# 1988 - 1990 Corvette: Service Bulletin: Power Steering Shudder / Groan

**Subject:** POWER STEERING SHUDDER/GROAN INSTALL P/S COOLER & HOSE

**Model and Year:** 1988-90 CORVETTE WITH 5.7L ENGINE

**Bulletin Number:** 90-376-3B - (10/25/1990)

**Step B Illustration**

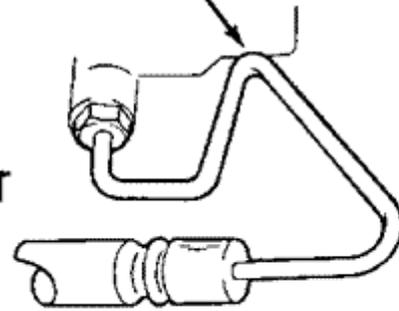
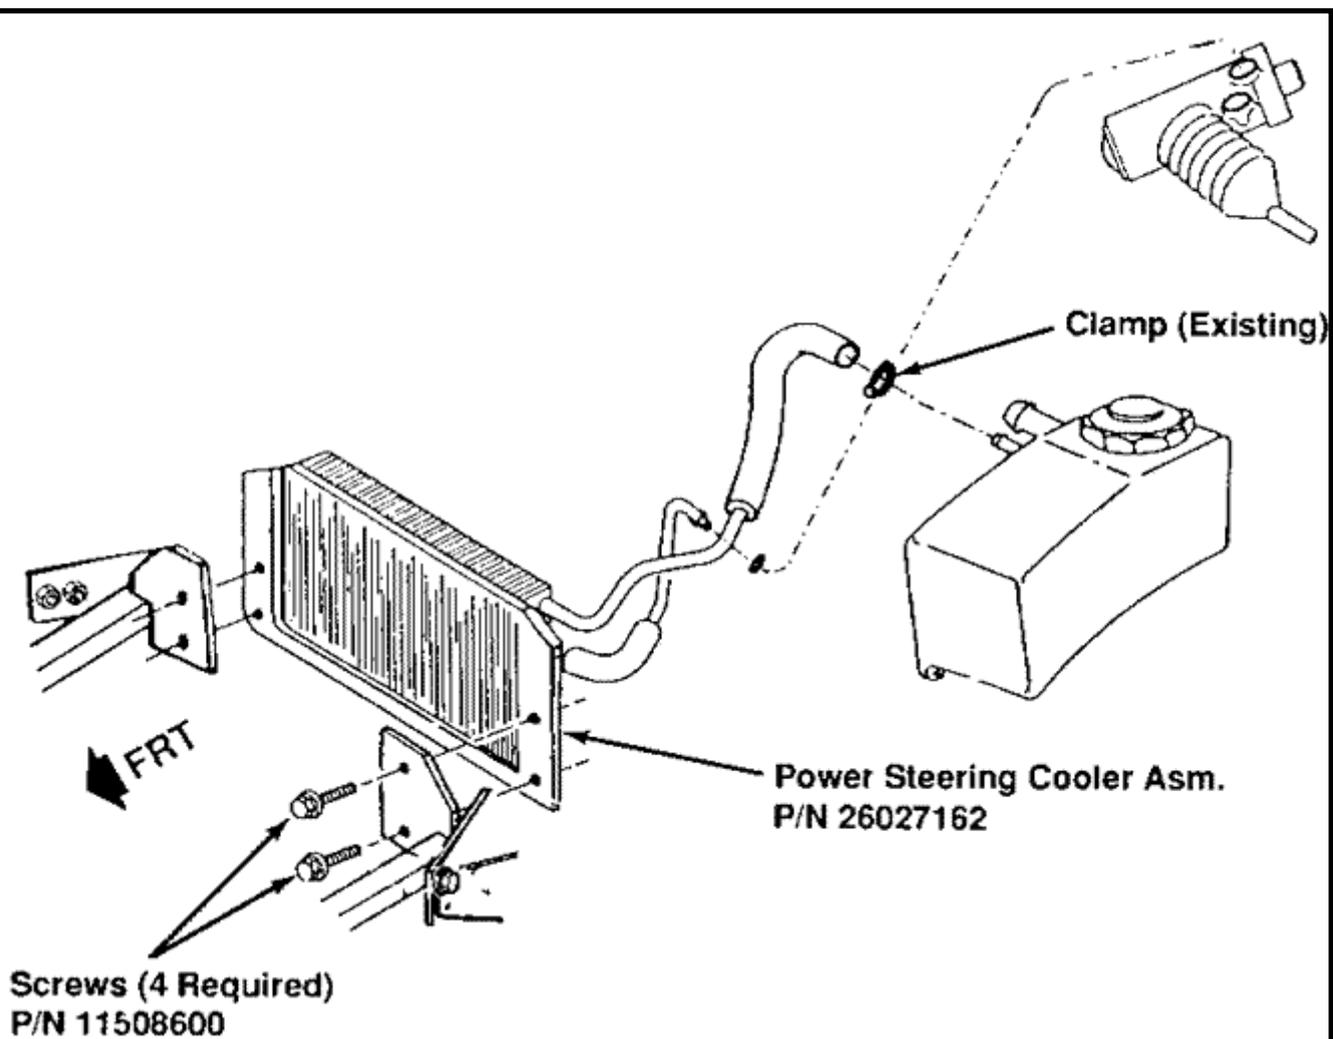
Replace existing pressure/inlet hose (pump to steering gear) with new assembly with internal tuner cable.

Power Steering  
Pressure/Inlet Hose Asm.  
P/N 262027177

Pipe at Pump End of  
Hose Asm. is to be  
Against Lower Corner  
of Pump

**Torque Specifications**  
Fittings (Pressure/Inlet Hose) – 28 N·m (21 lbs. ft.)

### Step C Illustration (1990 Vehicles)

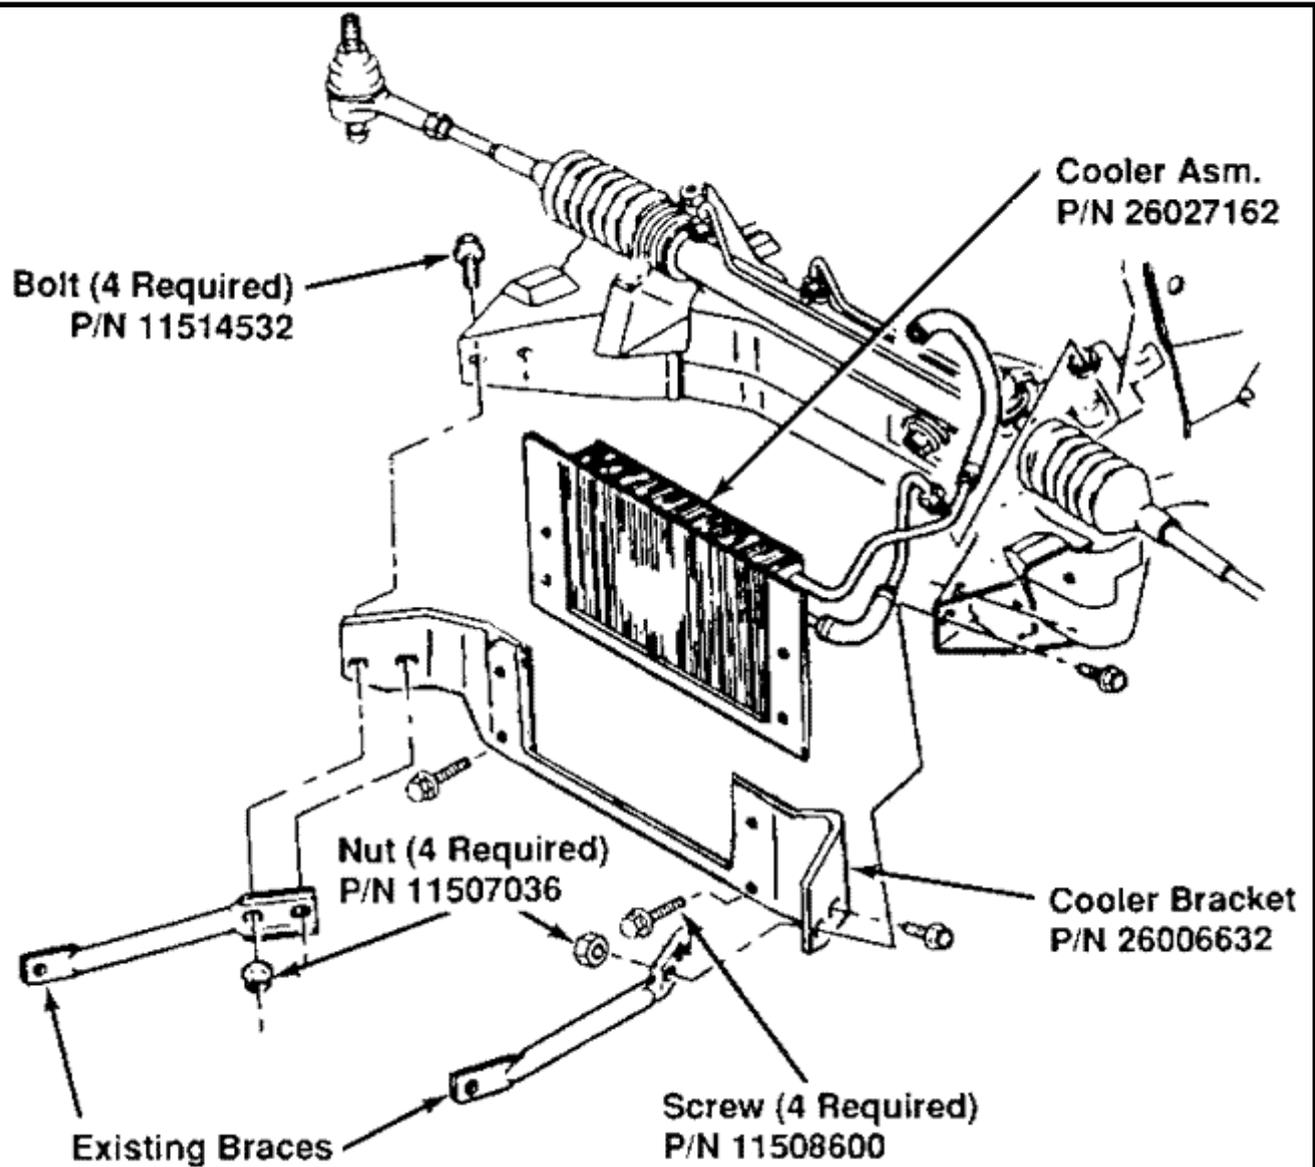
Replace existing power steering loop/pipe cooler with finned cooler that includes return hose with tuner cable.

### Torque Specifications

Fitting (Return/Outlet Hose) – 28 N•m (21 lbs. ft.)

Clamp (Reservoir Hose) – 2.5 N•m (22 lbs. in.)

Screws (Cooler/Bracket) – 10 N•m (89 lbs. in.)
